City of Portland, Maine - Building or Use Permit

Proposed Use:	Commercial Restaurant/PortHole - Interior Renovations to Update Fire Codes	Proposed Project Description:	Interior Renovations to Update Fire Codes
---------------	--	-------------------------------	---

SUBJECT: Porthole Tavern Restaurant / Comedy Connection: 2 Hr. Floor assembly reference

SUBJECT: Harbour's Edge/Comedy Connection/Porthole Tavern Life Safety Plans and Evaluation

Design No. 1209

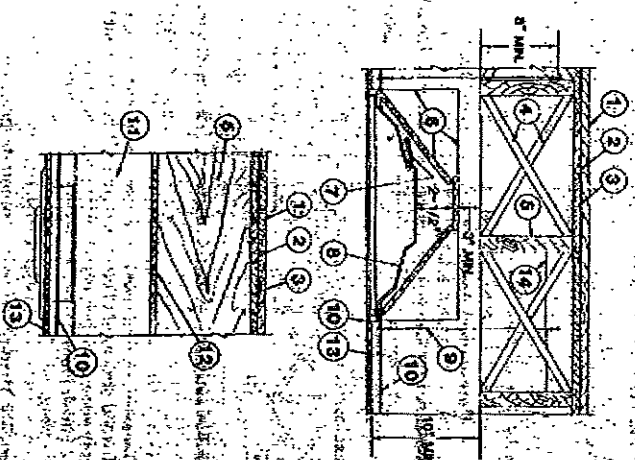
I met with Oliver Kiethly dba Cogee Entertainment today with regard to your comments and requests for information. Attached please find the U.L. listed floor assembly that I am referencing to extrapolate to the required 2 hr. floor/ceiling assembly.

The actual floor/ceiling assembly directly above the referenced restaurant/night clubs has 1x4 wood flooring over 2-1/2 tongue and groove wood decking which would give you a better fire rating than the L208 assembly listed. Assembly Design No. L208 is a 1-1/2 hr floor/ceiling assembly that when (1) layer of 5/8" Type X Firecode GWB was secured to the bottom of the timber floor framing would, in my opinion, equal to or exceed a 2 hr. floor/ceiling assembly. I discussed this with Steve Dodge at the office of the State Fire Marshall and he concurred with this proposal.

Please note that the floor members must be cross braced and solid blocked at their endpoints to attain this rating. *

Re: East Side Bents 13-47

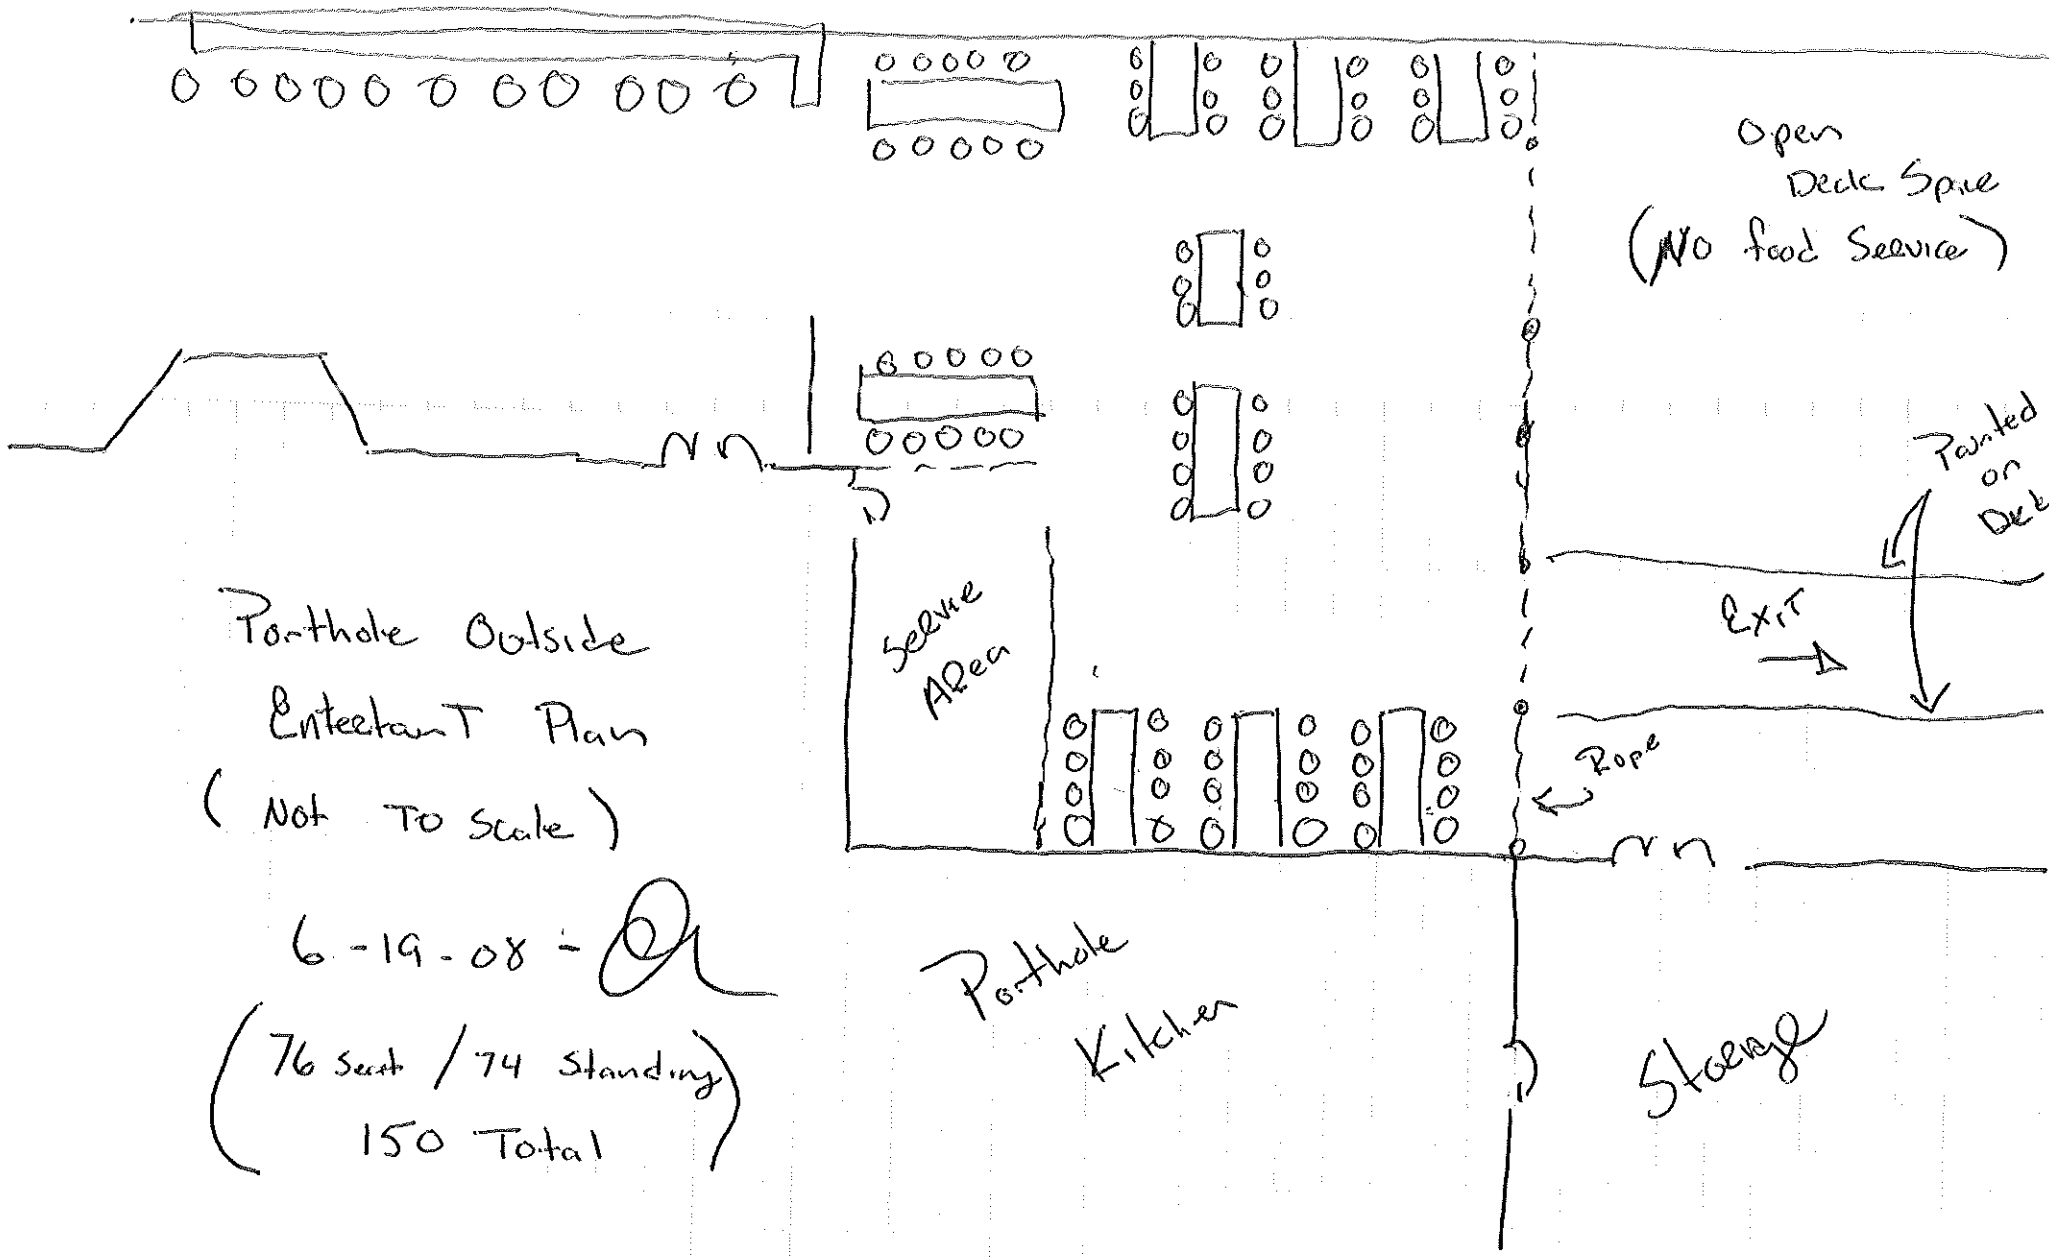
I have examined east side bents 13-47 exterior of the building line and find them to be adequate for use by the public at licensed capacity.
